Plan Change Request

➤ Specify the approved civil plans affected: C5-101, C5-201, C5-202, C5-201, C6-101, C6-201

Project:
**WSF Gold Gate
 Redevelopment**
 Civil Construction
 Permit

DWG. **C6-101**
 24 OF 27

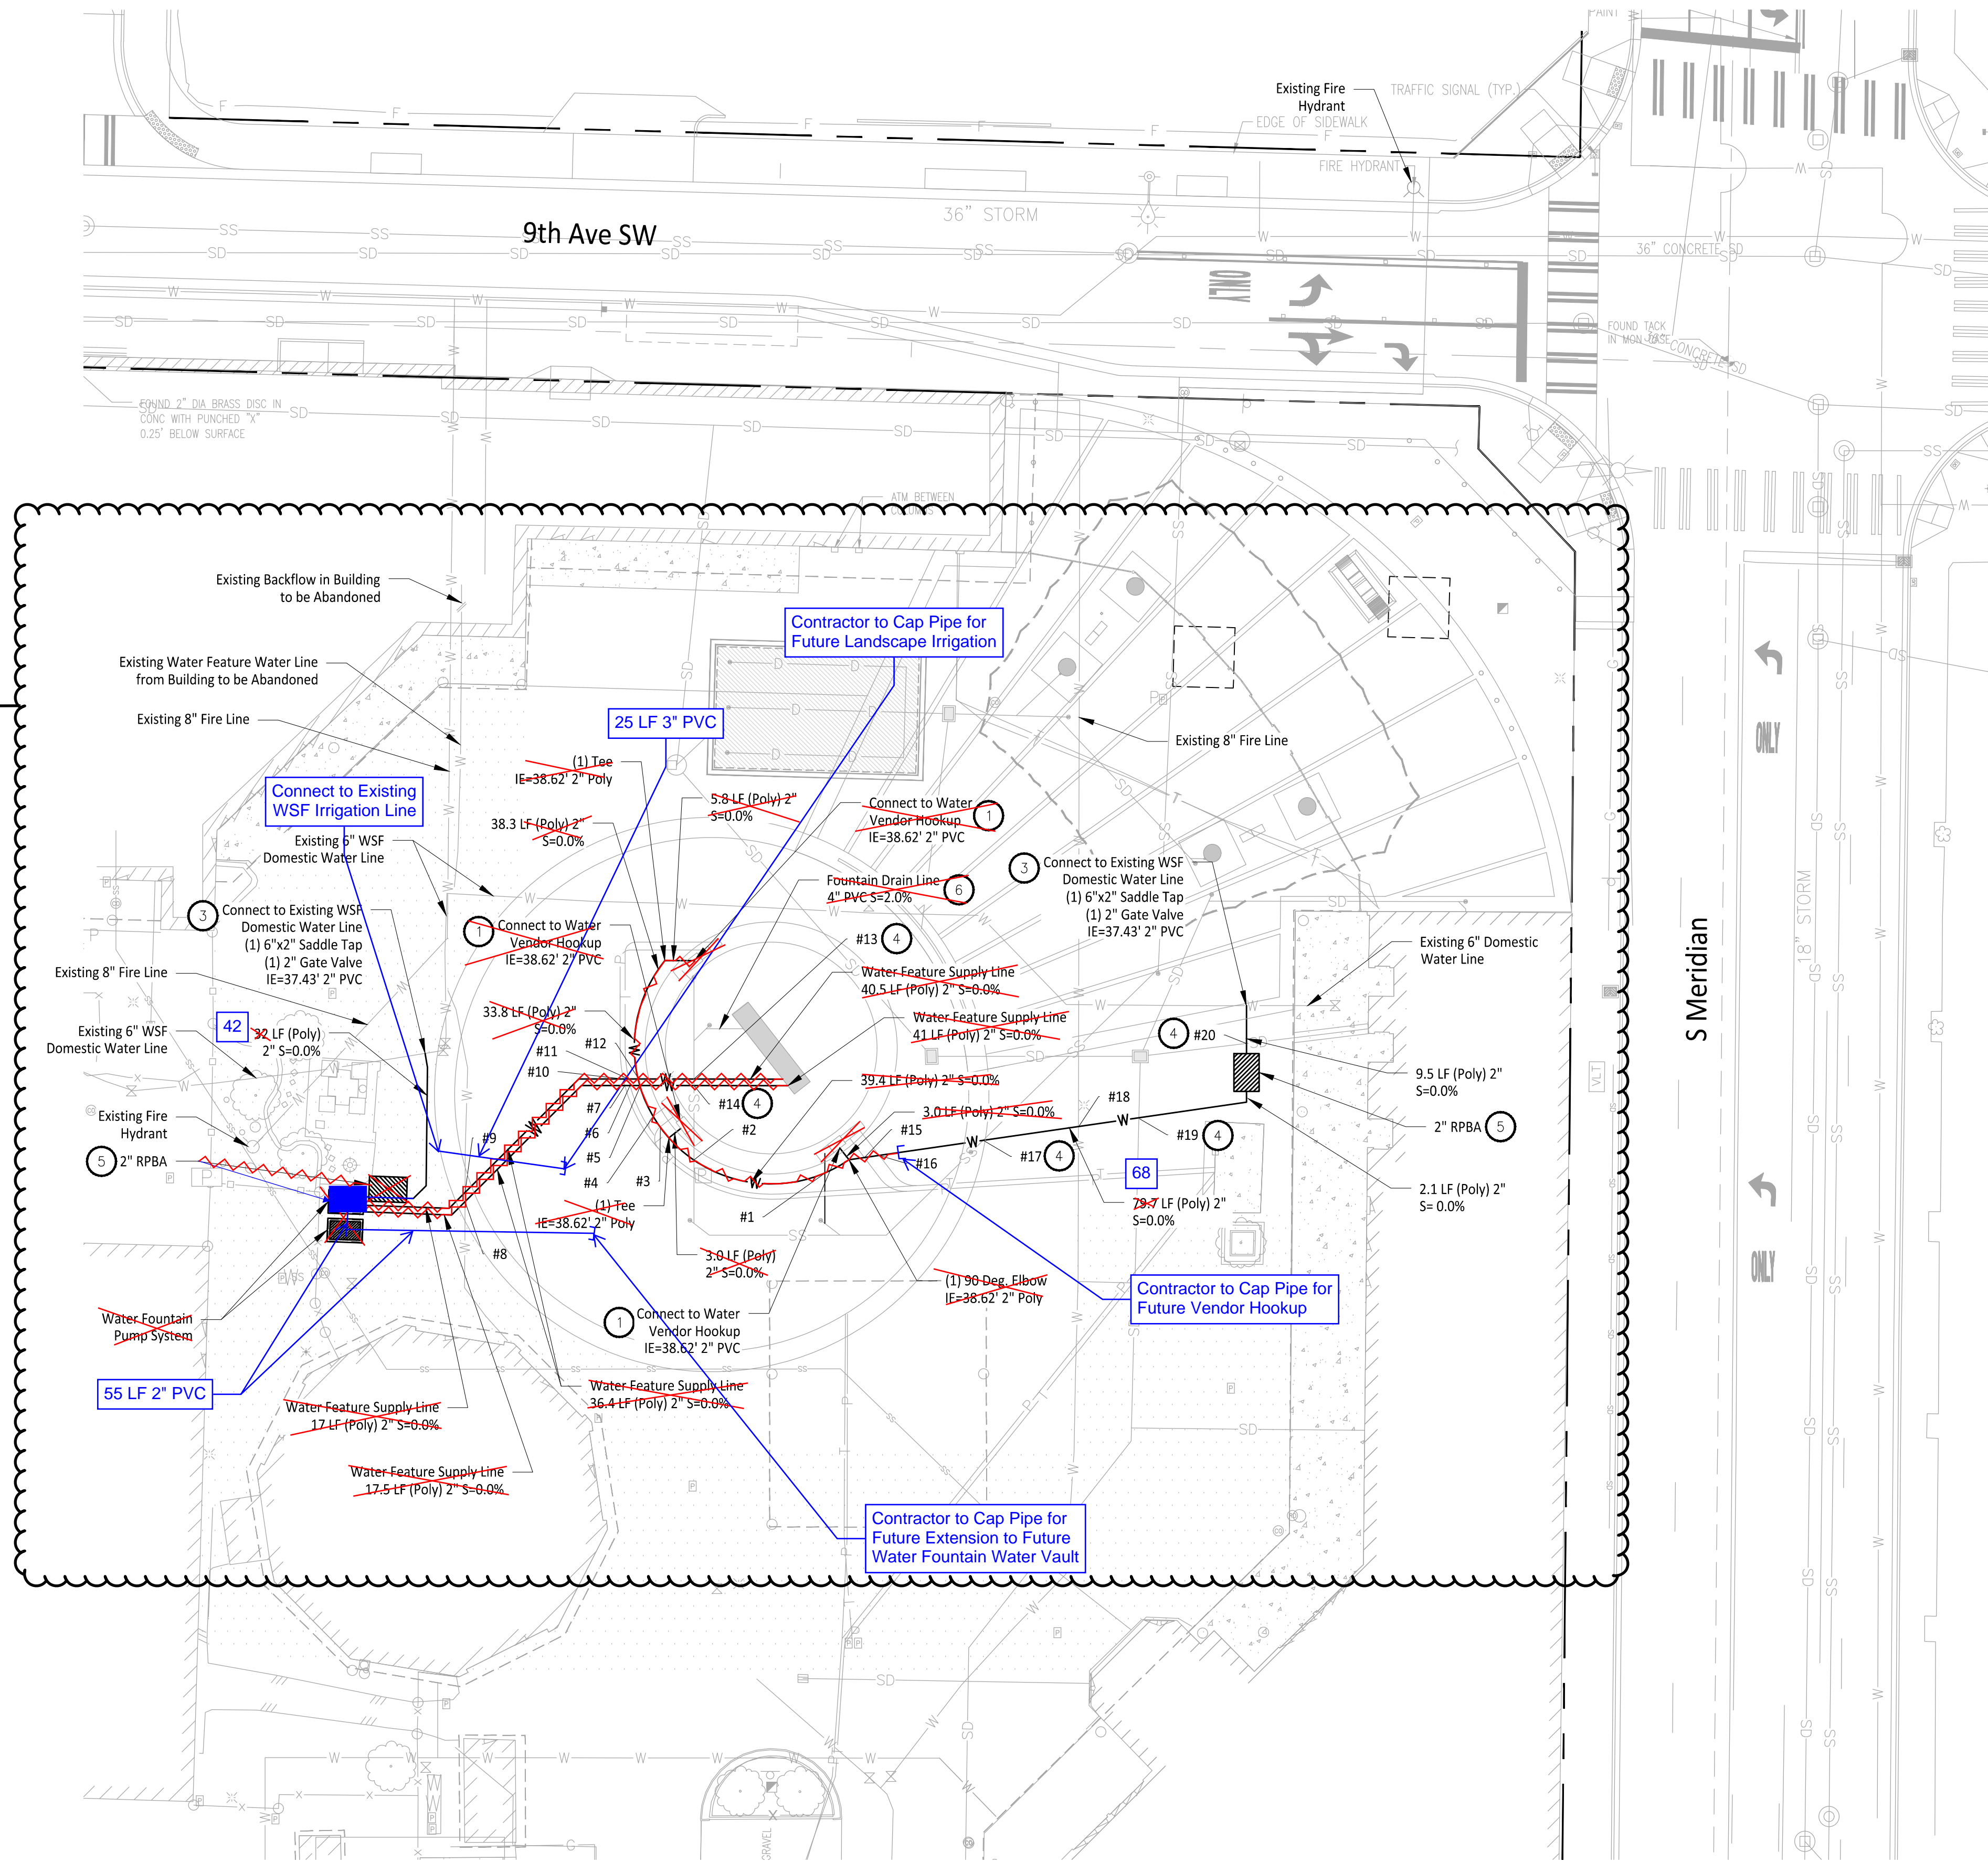
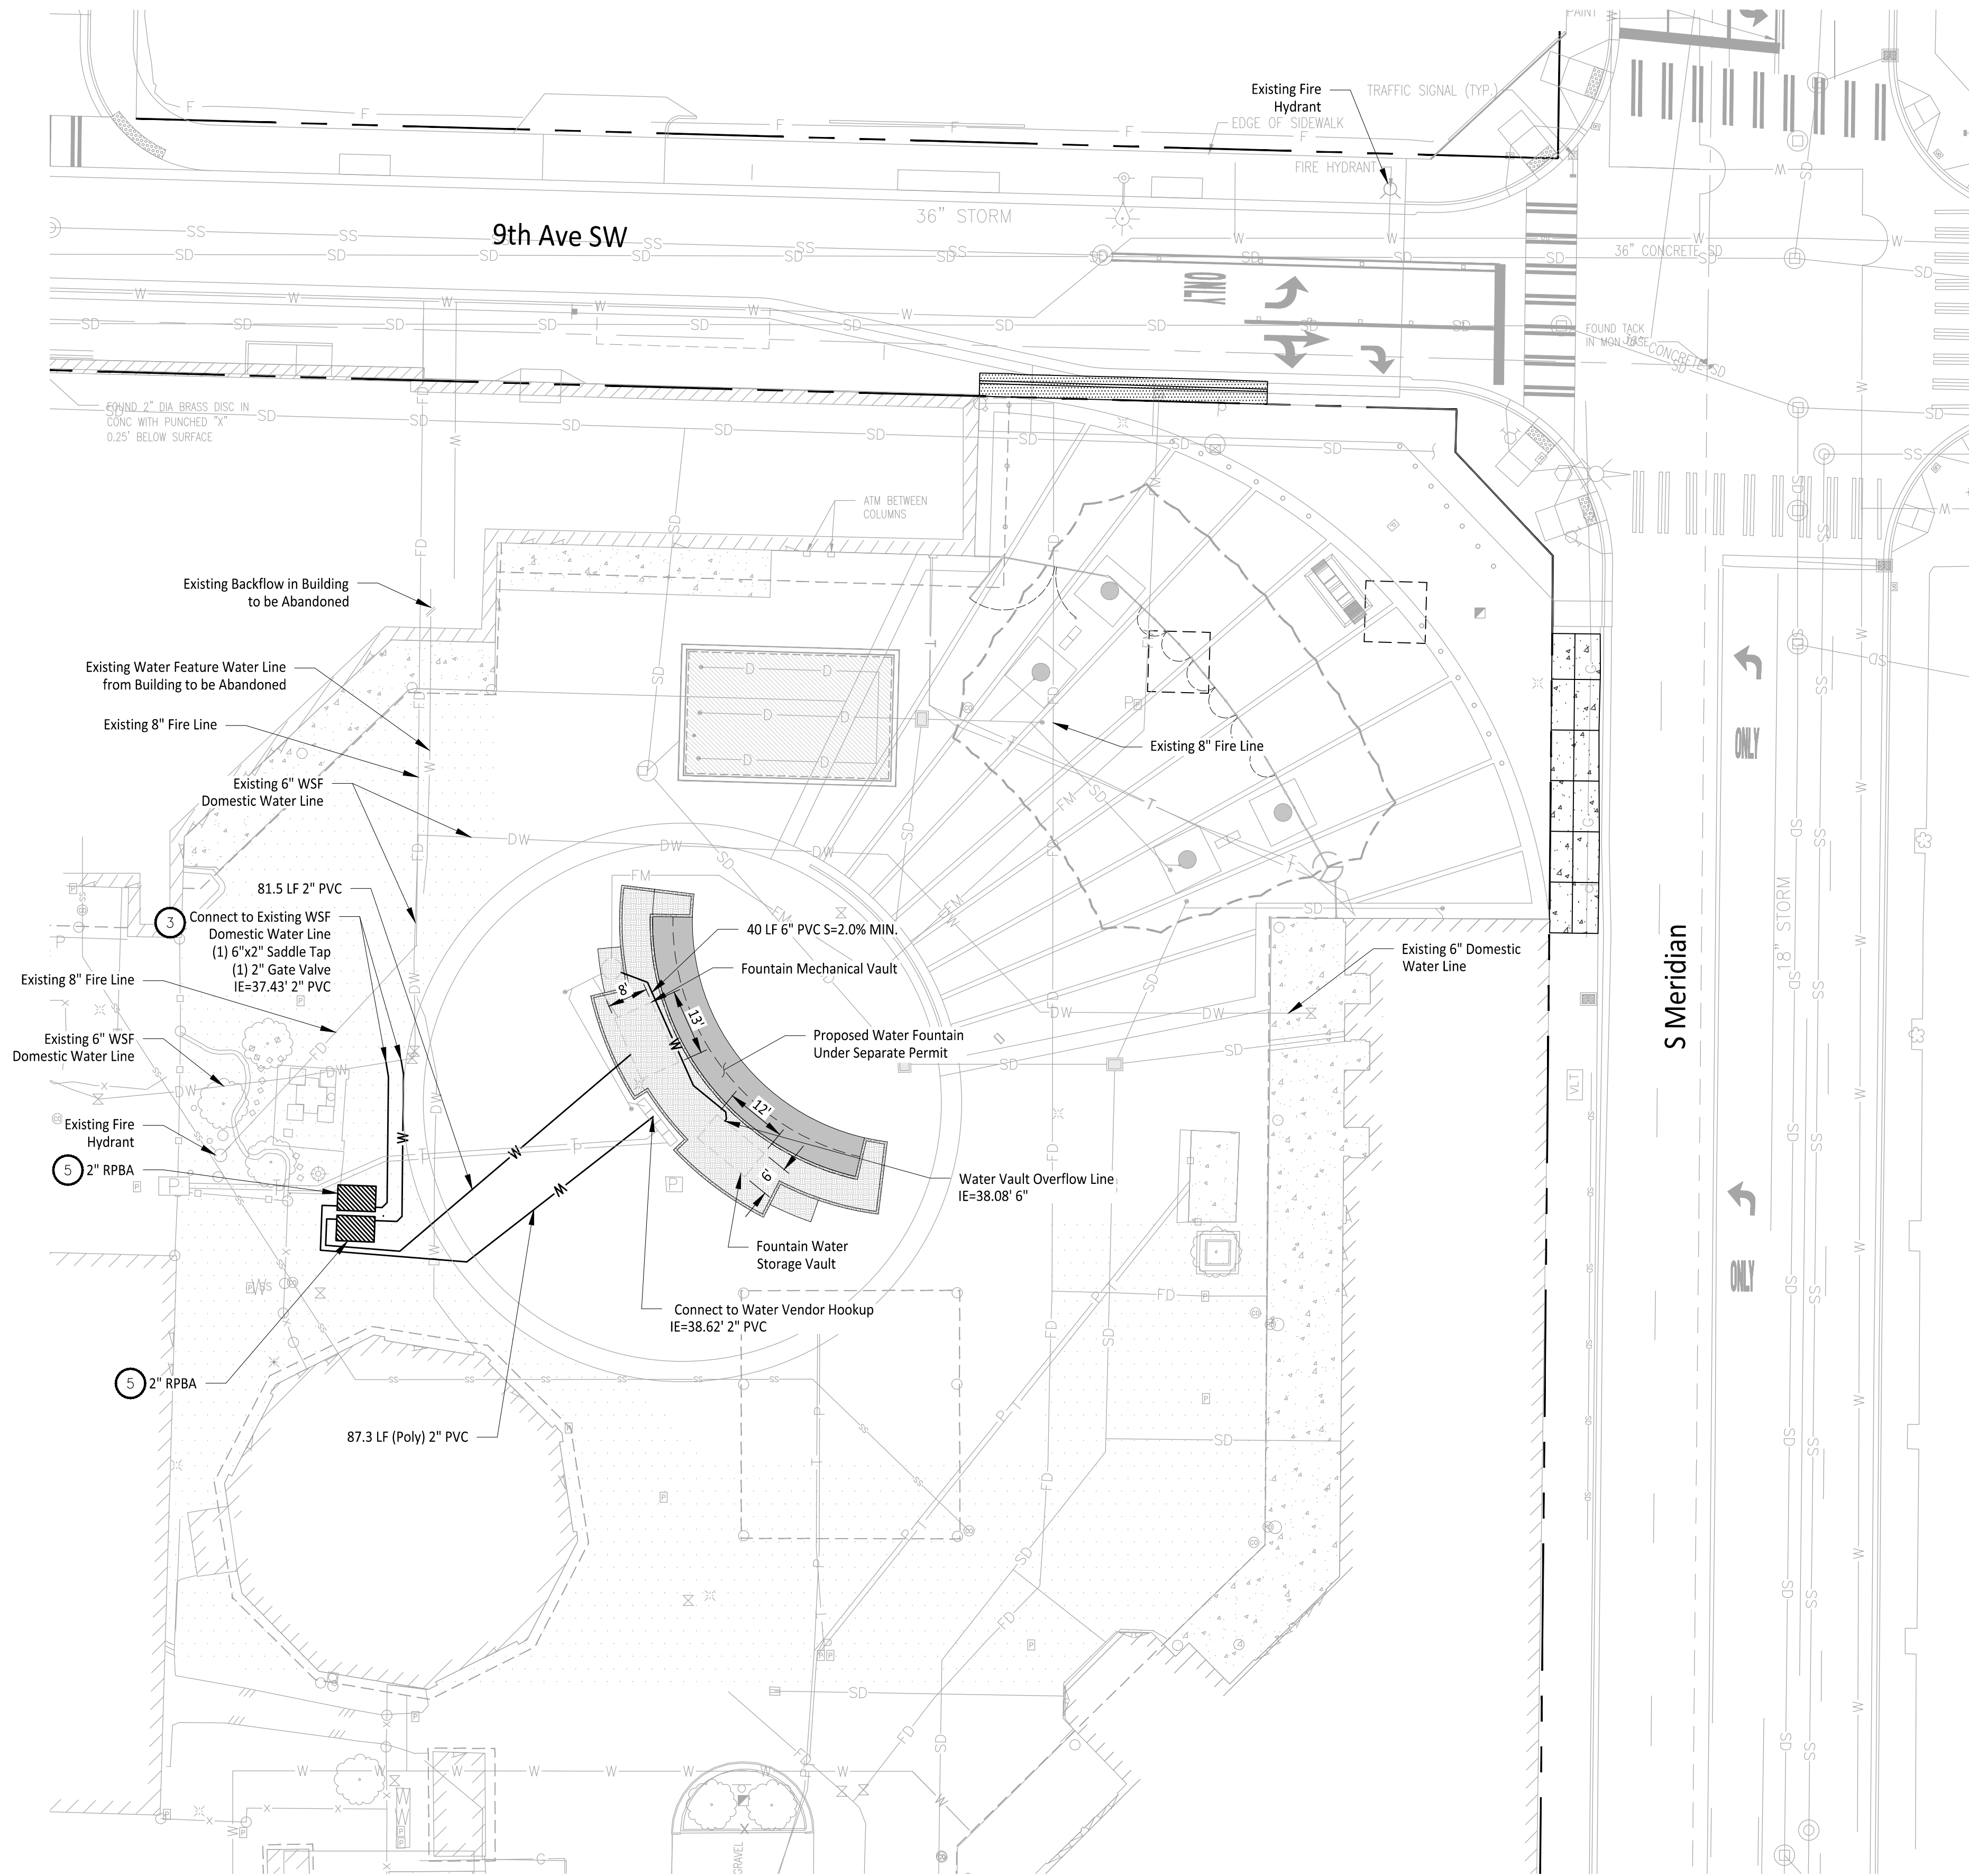
A new fountain structure and 4 vendor hookups (Sewer, Water, Power, Comm.) will be installed. The fountain will be permitted under a separate permit. A water connection will be made from the previously installed water stub to the proposed fountain mechanical vault. In addition, a new pre-built sewer lift station will be installed that will pump the fountain overflow/flushed water and vendor hookup discharge to a previously installed force main that connects out to a side sewer along 9th Ave SW.

- 5 Reduced Pressure Backflow Assembly to be installed Per City of Puyallup Standard Detail 03.04.02 on Sheet C6-202.
 - 6 Fountain to drain to Sewer
